RayDialer _{RX1}	
TITLE: RayDialer-RX1_U12	
Document Number:	REV: V1.2
Date: 29.12.2010 13:55:19	Sheet: 1/1

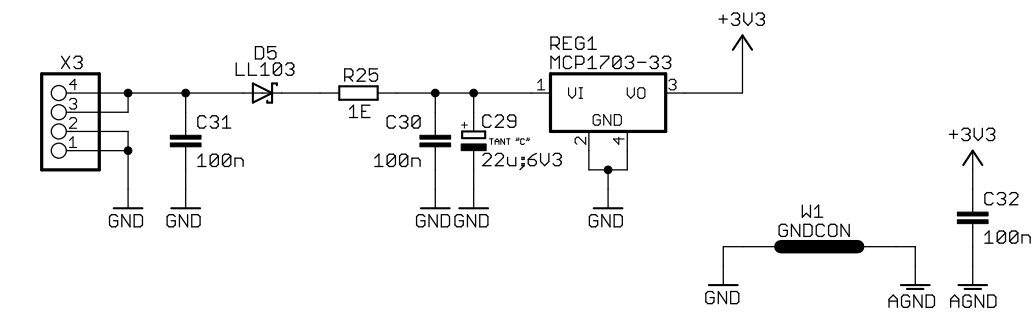
- R1, R9, R14, R19 changed to 4M7 (better default value)
- R29 was placed under I2C plug
- renamed and remapped channels (to same as in FW)

- Ups, VDDcore was connected to 3v3 ;-)
